Water Sensitive Urban Design (WSUD) Management Report

INDUSTRIAL DEVELOPMENT

LOT 3, 7 DURSLEY ROAD YENNORA

**RE: Application No. DA 2016/501/3 – 7 Dursley Road, Yennora NSW 2161-
 Response to Council Comments 15th January 2019.**

CIVIL DESIGN
CONCEPT STORMWATER
MANAGEMENT PLAN SHEET 1

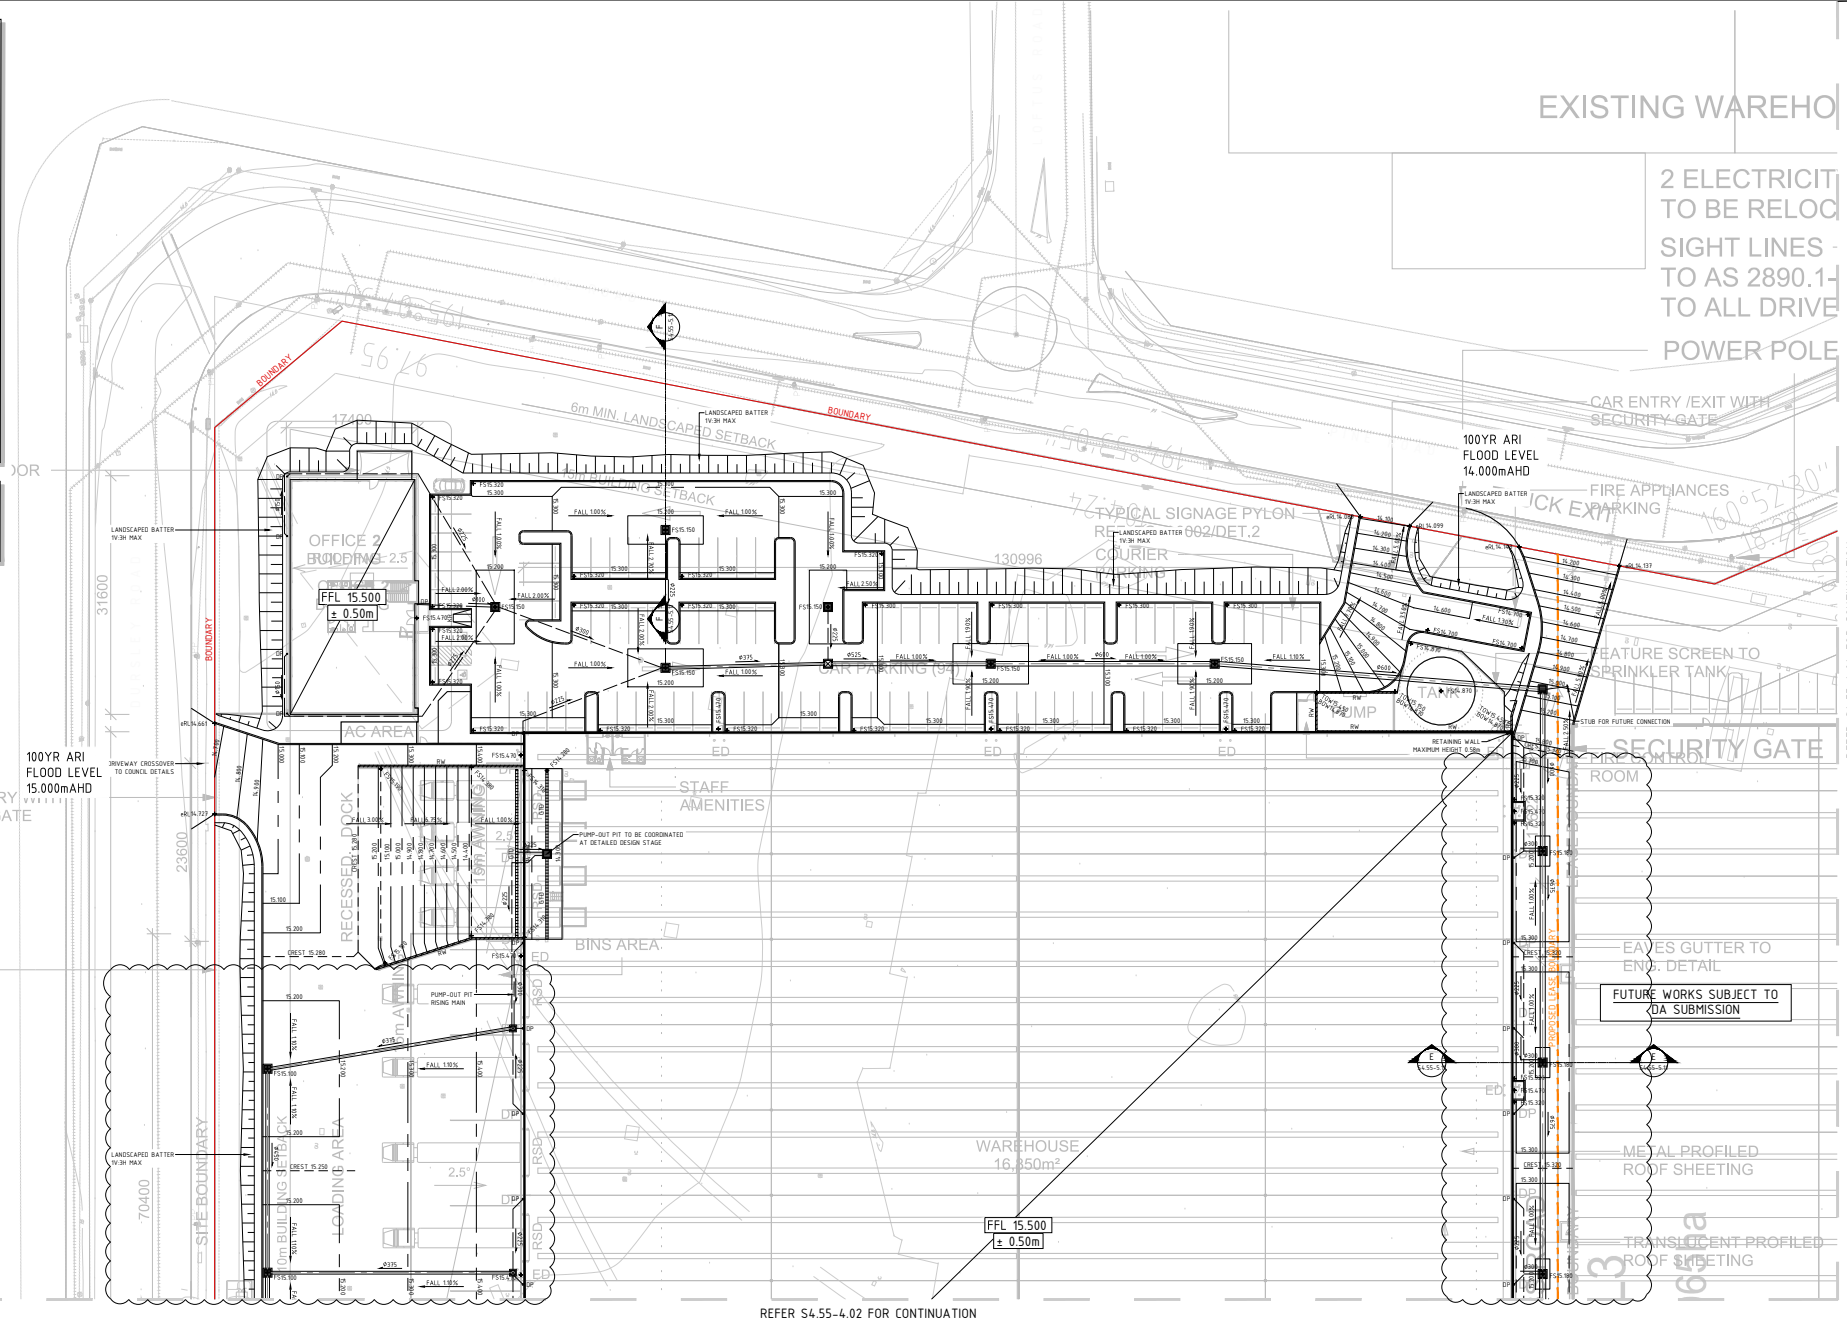
3. In comparing the landscape and engineering plans, there appears to be some inconsistency with regard to what is proposed within the Dursley Road frontage. The landscape plan indicates canopy trees within the setback to Dursley Road but the stormwater plans indicate a concrete channel that is in part open, and in part covered with a suspended slab. The landscape, stormwater and architectural plans are to be updated for consistency.	The Dursley road frontage design has been coordinated with the landscape and architectural plans. Refer to revised drawing 17260_4.02[4] and revised WSUD Report Rev 4 for further information.
